Sales Selection Sheet  
Checklist

**LOT 35 Model: 39-3356 A The Sprucehill**  
**PURCHASERS: SOUMIA Z. MURTUZA/**  
**VENDOR: Heathwood Homes (Whitby) Limited**

## CONSTRUCTION SUMMARY

**Lot: 35**  
**Model: 39-3356 A The Sprucehill**  
**Project/Phase: Country Lane / 1**

Sketch #1

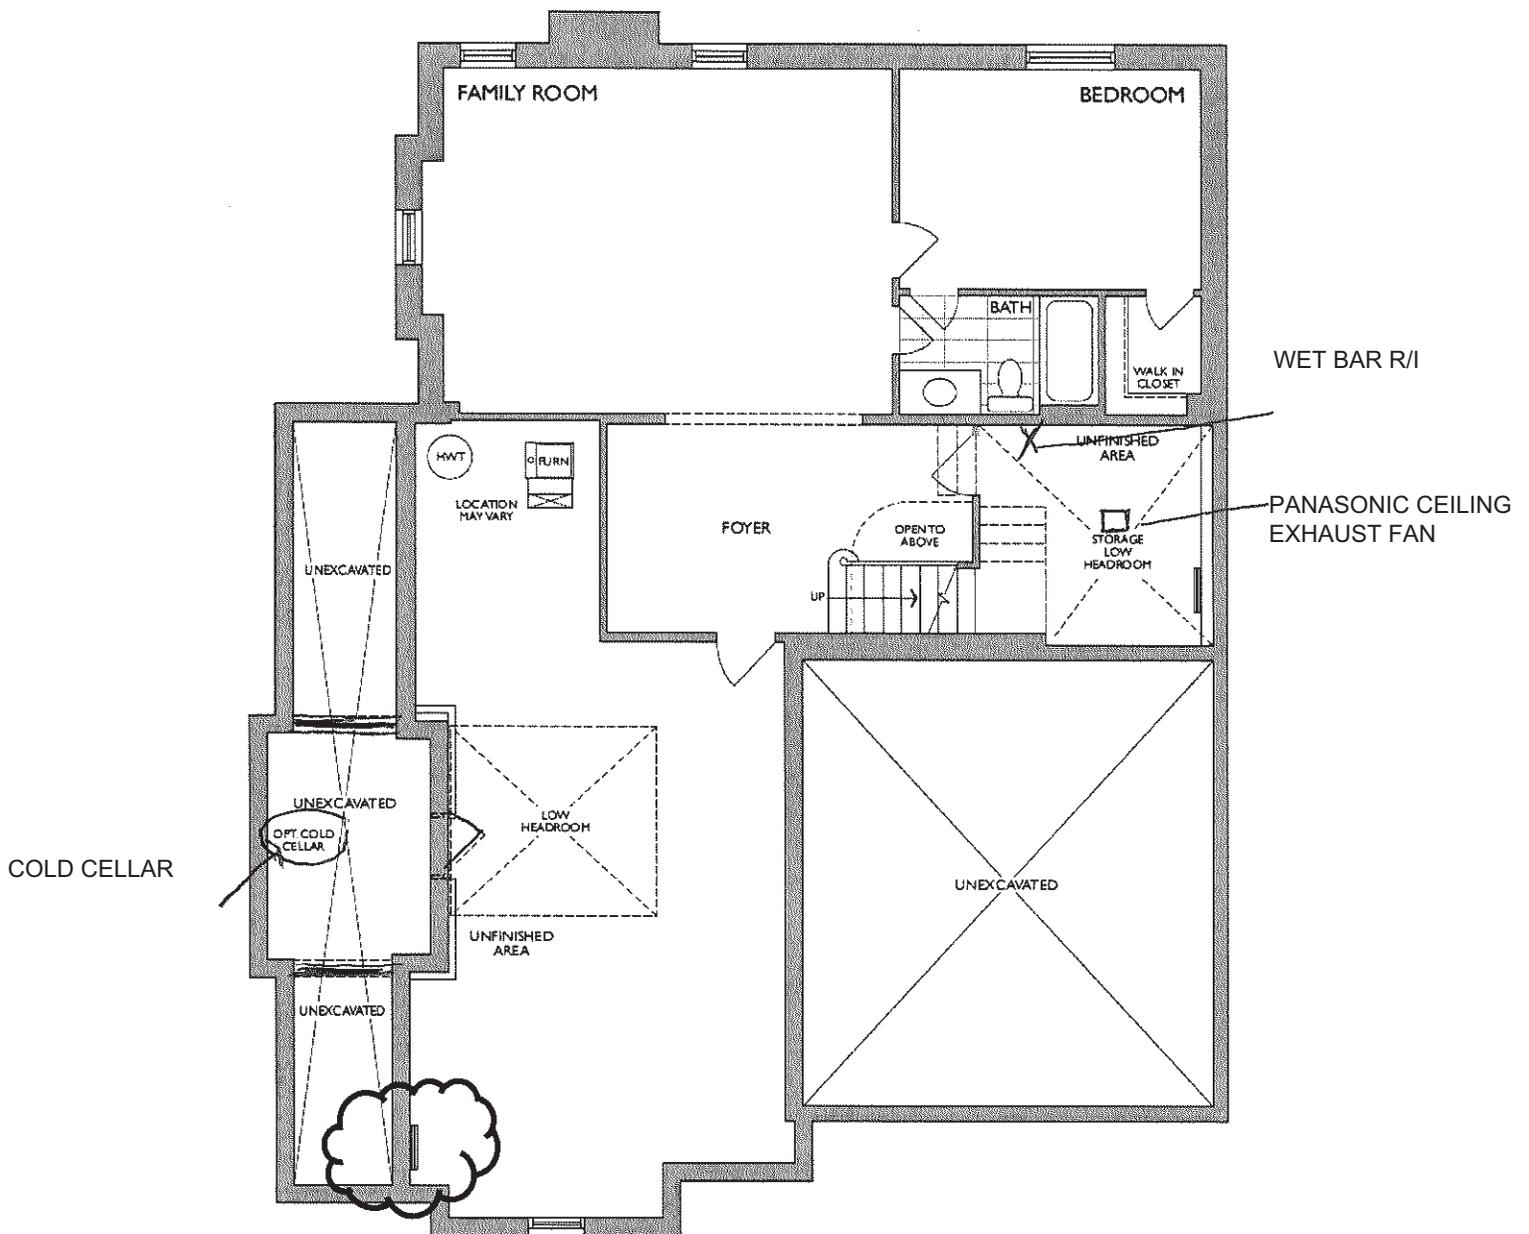
Invoice	Qty.	Description
1522 362,439  09Oct23	1	- COLD CELLAR - INSTALL COLD CELLAR - UPG CONCRETE DRAIN-Notify; DRYWALL-Notify; ELECTRICAL-Supply and install light and switch; FORMING-Notify; FRAMING-Notify; INTERIOR TRIM-Supply and install metal insulated slab door including hardware SKETCH # 1

Invoice	Qty.	Description
1522 362,391 09Oct23 **	1	- PLUMBING-OPTIONAL EXTRA-ROUGH- IN FOR FUTURE WET BAR -  INSTALL IN UNFINISHED BASEMENT AREA . SEE SKETCH # 1 <b>CONCRETE and DRAIN-Notify</b>
1522 362,391 09Oct23 **	1	KITCHEN - PLUMBING-OPTIONAL EXTRA-ROUGH- IN FOR FUTURE WET BAR -  INSTALL IN KITCHEN FOR FUTURE BAR SINK TO BE INSTALLED BY PURCHASER AFTER CLOSING <b>CONCRETE and DRAIN-Notify</b>  SEE SKETCH # 2

Invoice	Qty.	Description
1522 362,391 09Oct23	1	- PLUMBING-OPTIONAL EXTRA-ROUGH- IN FOR FUTURE WET BAR -  INSTALL IN UNFINISHED BASEMENT AREA . SEE SKETCH # 1 <b>CONCRETE and DRAIN-Notify</b>
1522 362,391 09Oct23	1	KITCHEN - PLUMBING-OPTIONAL EXTRA-ROUGH- IN FOR FUTURE WET BAR -  INSTALL IN KITCHEN FOR FUTURE BAR SINK TO BE INSTALLED BY PURCHASER AFTER CLOSING <b>CONCRETE and DRAIN-Notify</b>  SEE SKETCH # 2

\*\* SUPPLY AND INSTALL FIBERGLASS SOUND DAMPING INSULATION TO THE BASEMENT CEILING AND WALL INCLUDING STAIRCASE (FOR FINISHED AREA ONLY)

\* Electric Panel relocated

Sketch #2

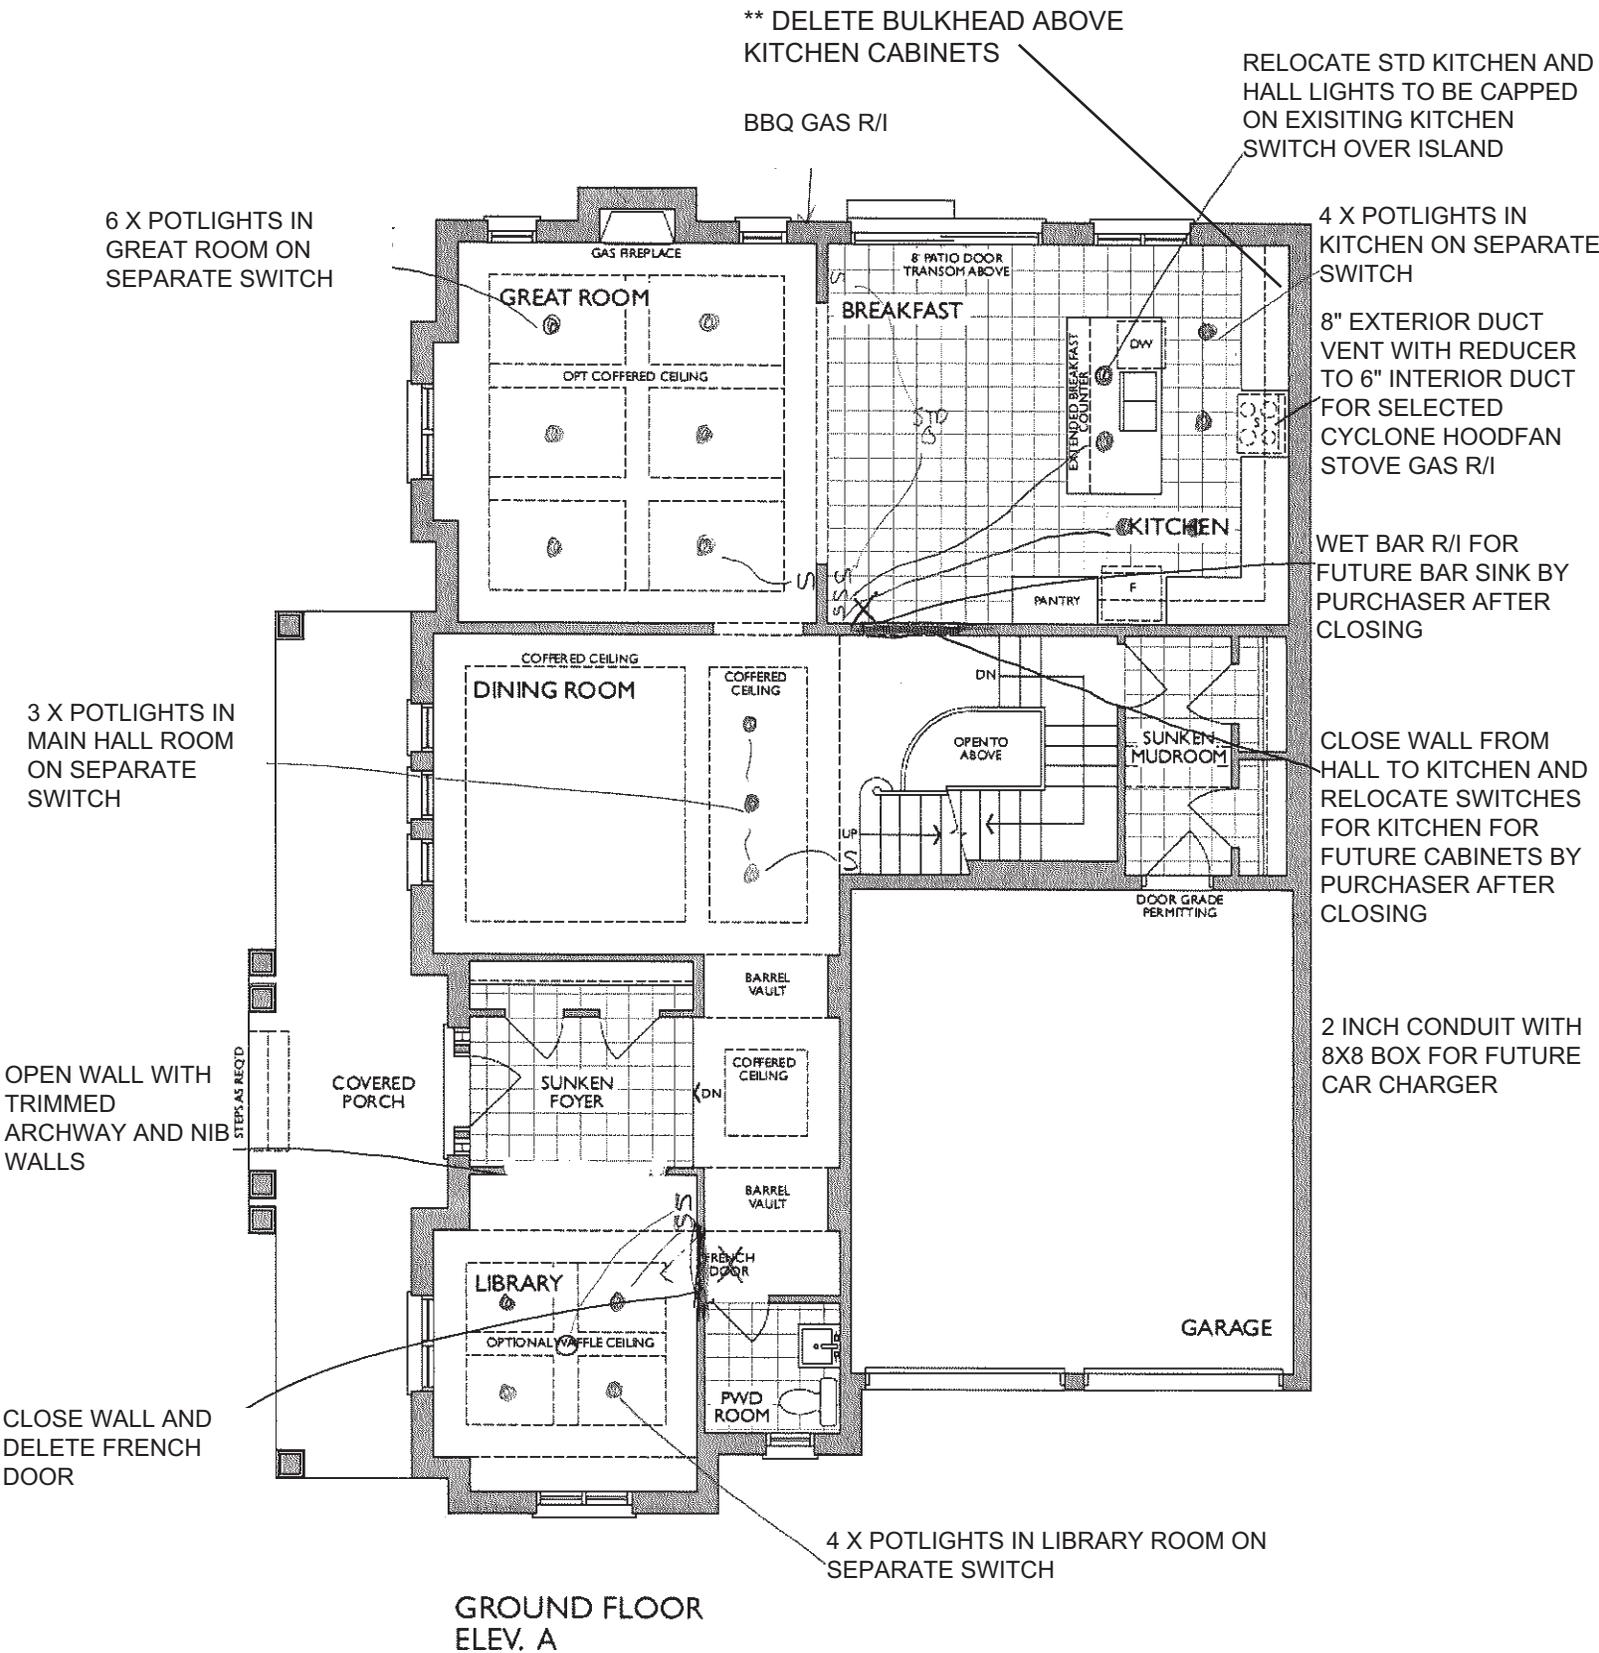
1522  09Oct23 ** NoCat	1	KITCHEN/BREAKFAST - OPTION 1 - CLOSE OFF ENTRANCE FROM STAIRS TO BREAKFAST ROOM  SKETCH # 2 <b>DRYWALL-Notify;ELECTRICAL-Notify;FRAMING-Notify;HARDWOOD-Notify;HEATING-Notify;INTERIOR TRIMS-Notify;PAINTING-Notify</b>
1522  09Oct23 ** NoCat	1	LIBRARY - DELETE FRENCH DOOR FROM HALLWAY TO LIBRARY AND CLOSE WALL  SKETCH # 2 <b>DRYWALL-Notify;ELECTRICAL-Notify;FRAMING-Notify;HARDWOOD-Notify;HEATING-Notify;PAINTING</b>

Invoice	Qty.	Description
1522 361,928 09Oct23	1	- ELECTRICAL-200 AMP SERVICE
1522 362,441 09Oct23 **	1	- DRYWALL - SMOOTH CEILINGS - SECOND FLOOR - UPG  <b>ELECTRICAL-Drop electrical boxes; PAINTING-Paint smooth ceiling</b>
1522 361,934 09Oct23	1	- ELECTRICAL-CAR CHARGER-2 INCH CONDUIT WITH 8X8 BOX FOR FUTURE CAR CHARGER  LOCATION TO BE DETERMINED BY SITE
1522 361,969 09Oct23	2	KITCHEN - ELECTRICAL-RELOCATION OF SWITCHES/LIGHTS (MUST SPECIFY LOCATION)-NOTE: PLUGS CANNOT BE RELOCATED- MUST PURCHASE ADDITIONAL OUTLET.  1) RELOCATE STANDARD KITCHEN LIGHT TO BE CENTERED +/- ON ISLAND. 2) RELOCATE STANDARD HALLWAY LIGHT TO BE CENTERED +/- WITH OTHER RELOCATED LIGHT ON ISLAND.BOTH TOGETHER ON SEPARATE SWITCH NOTE: SWITCHES FOR KITCHEN TO BE RELOCATED DUE TO CLOSED WALL (FUTURE CABINetry) SEE SKETCH # 2
1522 362,070 09Oct23 **	1	KITCHEN - HEATING/AIR-ROUGH-IN GAS LINE FOR GAS STOVE AT MAIN FLOOR (SEE SPECS) (HOOK-UP NOT INCLUDED) LEAVE STANDARD 120 VOLT ELECTRICAL OUTLET ON A SEPARATE CIRCUIT. * SPECIFY IF STANDARD 220V WILL STAY OR BE RELOCATED STANDARD 220V TO REMAIN SKETCH # 2 <b>ELECTRICAL-Notify</b>

1522  09Oct23 ** NoCat	1	LIBRARY - DELETE FRENCH DOOR FROM HALLWAY TO LIBRARY AND CLOSE WALL  SKETCH # 2 <b>DRYWALL-Notify;ELECTRICAL-Notify;FRAMING-Notify;HARDWOOD-Notify;HEATING-Notify;PAINTING-Notify</b>
1522 362,450 09Oct23	1	UPPER BASEMENT STAIRS LANDING - ELECTRICAL - CEILING EXHAUST FAN (INCLUDING SWITCH) 50/80/110CFM PANASONIC WHISPER GREEN MODEL: FV0511VK1  INSTALL ON CEILING IN UNFINISHED BASEMENT AREA SKETCH # 1
1522  09Oct23 ** NoCat	1	KITCHEN - DELETE BULKHEADS IN THE KITCHEN ABOVE CABINETS. CONFIRMED BULKHEADS ARE NOT REQUIRED.  <b>DRYWALL-Notify;ELECTRICAL-Notify;FRAMING-Notify;HEATING-Notify;PAINTING-Notify</b>  NOTE: THERE WILL BE A STANDARD BULKHEAD ON REAR WALL OF KITCHEN/BREAKFAST ROOM ALONG WINDOW AND PATIO DOOR.

Invoice	Qty.	Description
1522 09Oct23 ** NoCat	1	LIBRARY - OPEN UP WALL BETWEEN FOYER AND LIBRARY TRIMMED ARCHWAY WITH NIB WALLS ON BOTH ENDS  SKETCH # 2 <b>DRYWALL-Notify;ELECTRICAL-Notify;FRAMING-Notify;HARDWOOD-Notify;HEATING-Notify;INTERIOR TRIMS-Notify;PAINTING-Notify</b>
1522 09Oct23 ** NoCat	1	KITCHEN/BREAKFAST - OPTION 1 - CLOSE OFF ENTRANCE FROM STAIRS TO BREAKFAST ROOM  SKETCH # 2 <b>DRYWALL-Notify;ELECTRICAL-Notify;FRAMING-Notify;HARDWOOD-Notify;HEATING-Notify;INTERIOR TRIMS-Notify;PAINTING-Notify</b>
1522 09Oct23 ** NoCat	1	LIBRARY - DELETE FRENCH DOOR FROM HALLWAY TO LIBRARY AND CLOSE WALL  SKETCH # 2 <b>DRYWALL-Notify;ELECTRICAL-Notify;FRAMING-Notify;HARDWOOD-Notify;HEATING-Notify;PAINTING-Notify</b>

Invoice	Qty.	Description
1522 362,067 09Oct23	1	- HEATING/AIR-ROUGH-IN GAS LINE FOR BBQ AT MAIN FLOOR UP TO 40 FT (QUICK CONNECT NOT INCLUDED); ELECTRICAL OUTLET PRICED SEPARATELY IF REQUIRED SEE SKETCH # 2
1522 362,070 09Oct23	1	KITCHEN - HEATING/AIR-ROUGH-IN GAS LINE FOR GAS STOVE AT MAIN FLOOR (SEE SPECS) (HOOK-UP NOT INCLUDED) LEAVE STANDARD 120 VOLT ELECTRICAL OUTLET ON A SEPARATE CIRCUIT. * SPECIFY IF STANDARD 220V WILL STAY OR BE RELOCATED STANDARD 220V TO REMAIN SKETCH # 2 <b>ELECTRICAL-Notify</b>
1522 09Oct23 ** NoCat	1	LIBRARY - OPEN UP WALL BETWEEN FOYER AND LIBRARY TRIMMED ARCHWAY WITH NIB WALLS ON BOTH ENDS SKETCH # 2 <b>DRYWALL-Notify;ELECTRICAL-Notify;FRAMING-Notify;HARDWOOD-Notify;HEATING-Notify;INTERIOR TRIMS-Notify;PAINTING-Notify</b>
1522 09Oct23 ** NoCat	1	KITCHEN/BREAKFAST - OPTION 1 - CLOSE OFF ENTRANCE FROM STAIRS TO BREAKFAST ROOM SKETCH # 2 <b>DRYWALL-Notify;ELECTRICAL-Notify;FRAMING-Notify;HARDWOOD-Notify;HEATING-Notify;INTERIOR TRIMS-Notify;PAINTING-Notify</b>

1522 362,064 09Oct23	1	KITCHEN - HEATING / AIR CONDITIONING-INCREASE RANGE HOOD DUCT SIZE FROM 6 IN TO 8 IN CHIMNEY HOODFAN REQUIRES 6" DUCT- INSTALL REDUCER FROM 8" DUCT ON EXTERIOR WALL ( FOR FUTURE HOODFAN INSTALLED BY PURCHASER AFTER CLOSING) TO 6" ON INTERIOR FOR SELECTED CYCLONE 36" HOODFAN SKETCH # 2
1522 09Oct23 ** NoCat	1	LIBRARY - DELETE FRENCH DOOR FROM HALLWAY TO LIBRARY AND CLOSE WALL SKETCH # 2 <b>DRYWALL-Notify;ELECTRICAL-Notify;FRAMING-Notify;HARDWOOD-Notify;HEATING-Notify;PAINTING-Notify</b>
1522 09Oct23 ** NoCat	1	KITCHEN - DELETE BULKHEADS IN THE KITCHEN ABOVE CABINETS. CONFIRMED BULKHEADS ARE NOT REQUIRED. <b>DRYWALL-Notify;ELECTRICAL-Notify;FRAMING-Notify;HEATING-Notify;PAINTING-Notify</b>  NOTE: THERE WILL BE A STANDARD BULKHEAD ON REAR WALL OF KITCHEN/BREAKFAST ROOM ALONG WINDOW AND PATIO DOOR.

1522  09Oct23 ** NoCat	1	KITCHEN - DELETE BULKHEADS IN THE KITCHEN ABOVE CABINETS. CONFIRMED BULKHEADS ARE NOT REQUIRED.  <b>DRYWALL-Notify;ELECTRICAL-Notify;FRAMING-Notify;HEATING-Notify;PAINTING-Notify</b>  NOTE: THERE WILL BE A STANDARD BULKHEAD ON REAR WALL OF KITCHEN/BREAKFAST ROOM ALONG WINDOW AND PATIO DOOR.

SECOND FLOOR  
ELEV. A

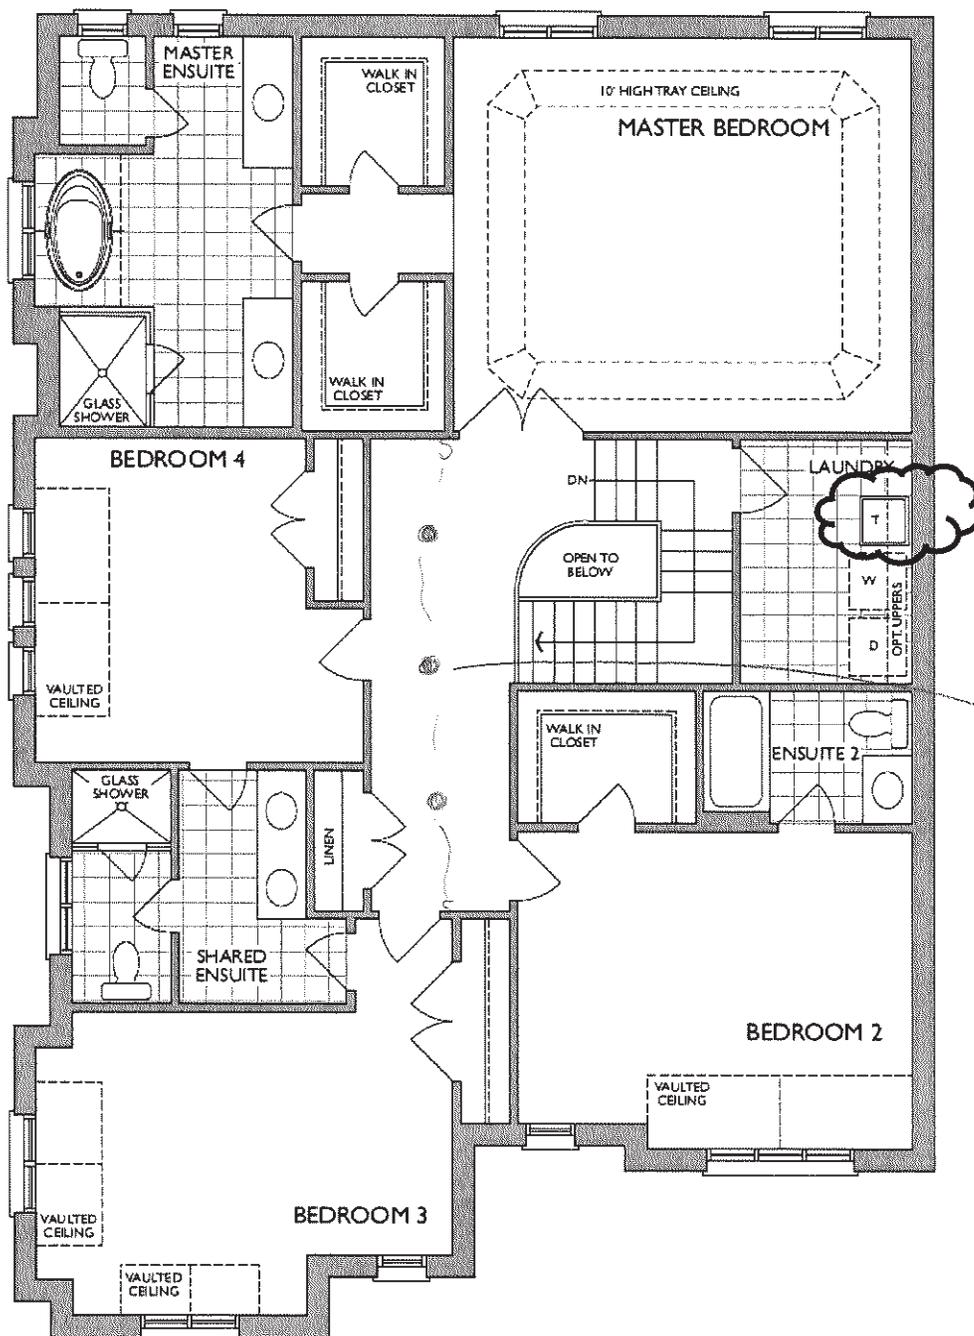
\* Opt. Uppers extends over the laundry tub
